APPLICATION NUMBER:	PD 26-0426	
ZHM HEARING DATE:	May 26, 2026	
BOCC PUBLIC HEARING DATE:	July 21, 2026	Case Reviewer: Jared Follin

CITRUS PARK MULTI-FAMILY PLANNED DEVELOPMENT GENERAL SITE PLAN

AGENCY REVIEW COMMENT SHEET

PETITION NO: PD 26-0426

2.4 Proposed Site Plan (partial provided below for size and orientation purposes. See Section 8.0 for full site plan)

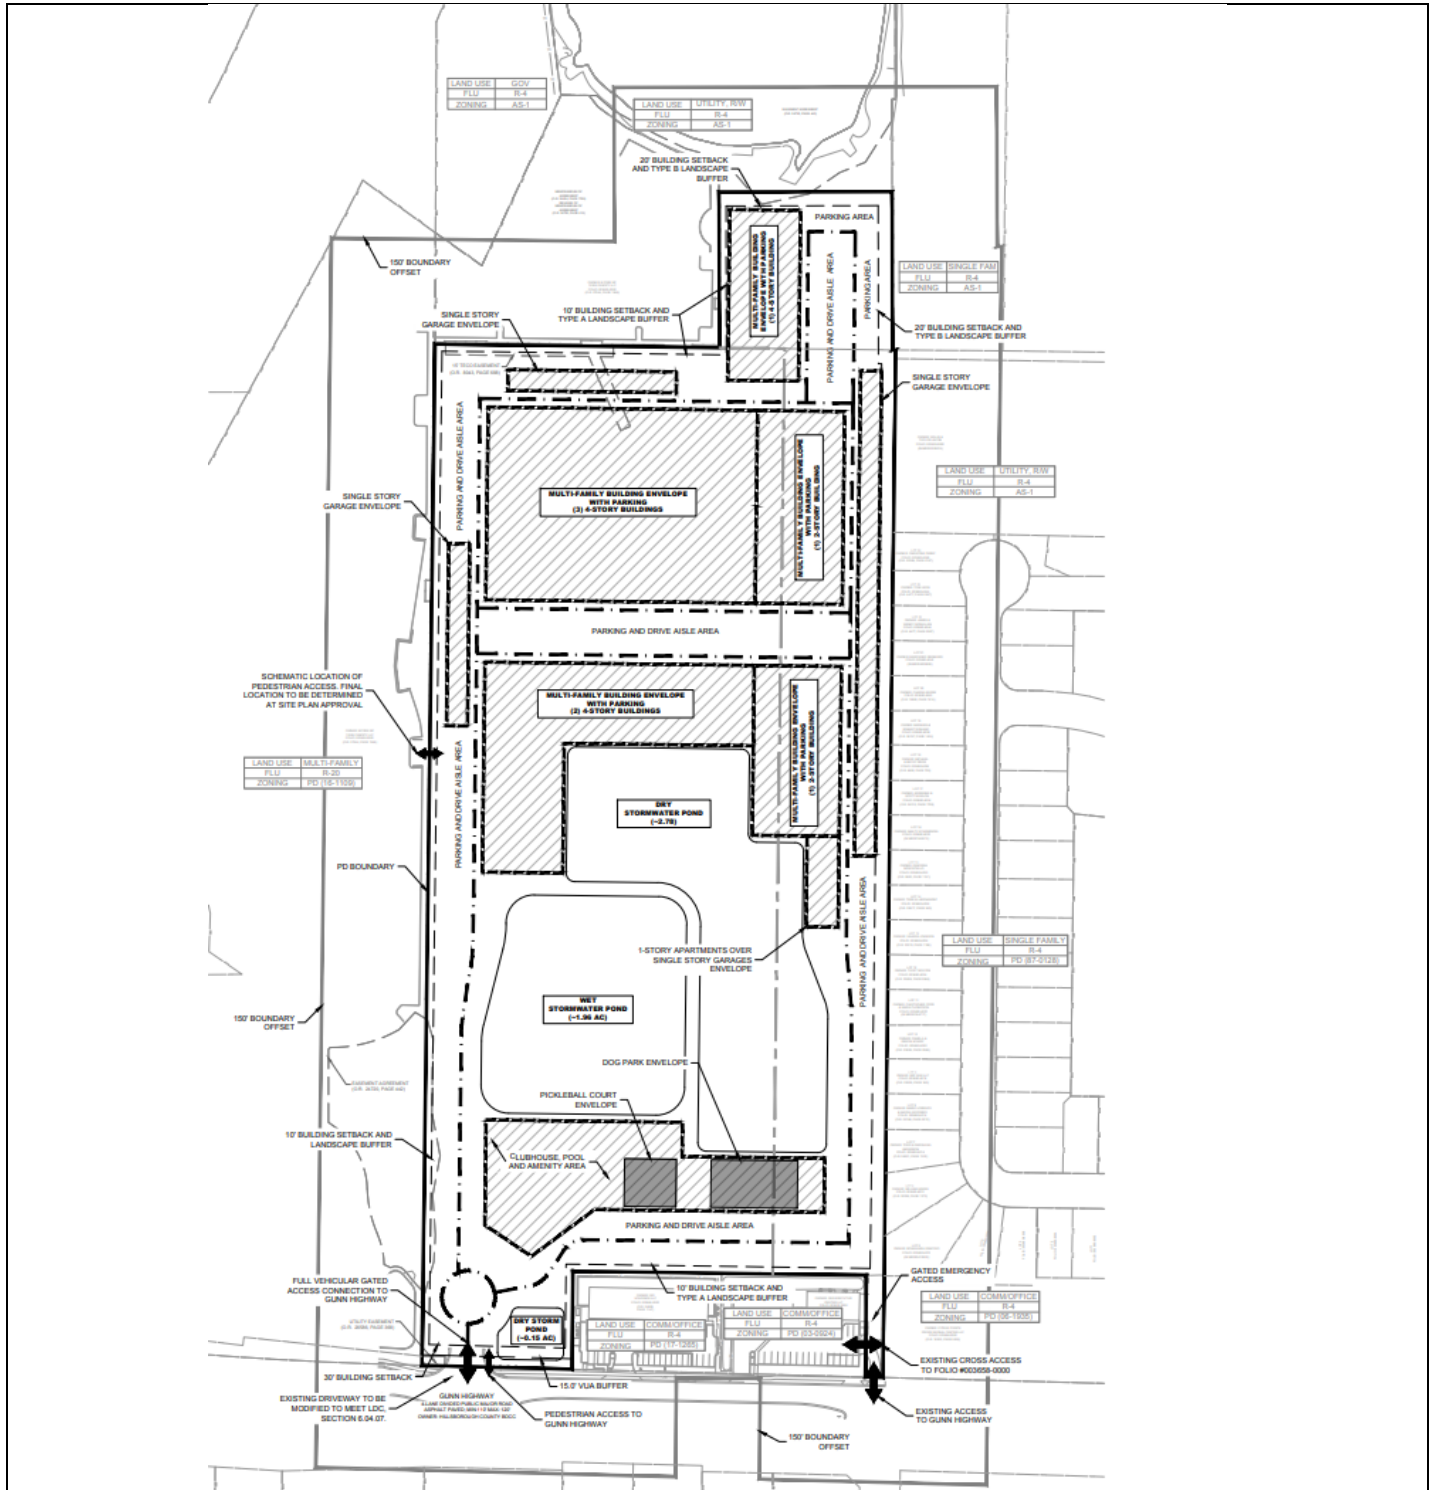
1. Prior to PD General Site Plan certification, the applicant shall revise the PD site plan label stating “Existing driveway to be modified to meet LDC, Section 6.04.07.” to “Existing driveway to be modified to meet the LDC, Sec. 6.04.04.A.3. residential development maximum driveway length.”
2. Prior to General Site Plan certification, the applicant shall revise the PD site plan proposed general vehicular general circulation pattern to connect to the proposed gated emergency access.
3. General Site Plan to provide a maximum building height for the amenity center at 35 feet.

- Prior to PD site plan certification, the applicant shall revise the PD site plan label stating “Existing driveway to be modified to meet LDC, Section 6.04.07.” to “Existing driveway to be modified to meet the LDC, Sec. 6.04.04.A.3. residential development maximum driveway length.”
- Prior to PD site plan certification, the applicant shall revise the PD site plan proposed general vehicular general circulation pattern to connect to the proposed gated emergency access.
